## SERVICE BULLETIN NO. 146

### Visual Cooking PT-100 temperature sensors Replacement of plug connections

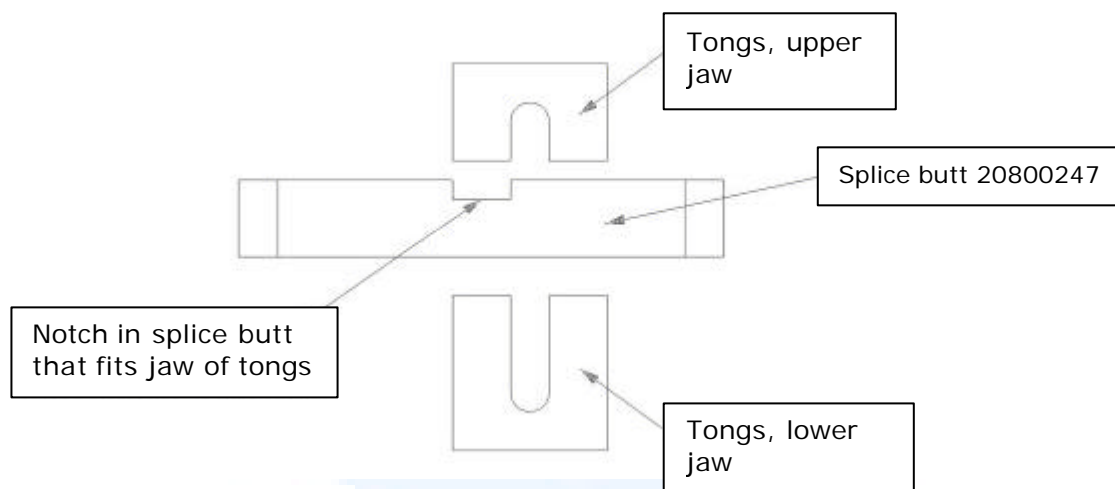
Unfortunately, we have found that over time the plug connections for the following PT-100 temperature sensors may deteriorate:

- P1: Sensor, oven chamber
- P2: Sensor, steam generator
- P3: Sensor, drain (condensation)

Furthermore, there may be poor plug connection at

S2 and S2A: Thermo-switch and revolution signal for fan motor.

**Consequently, these plug connections have been replaced by splice butts which are squeezed onto the wires as shown below. The part No. of the splice butt is 20800247.**

Of course, the splice butts can also replace plug connections on ovens in operation.
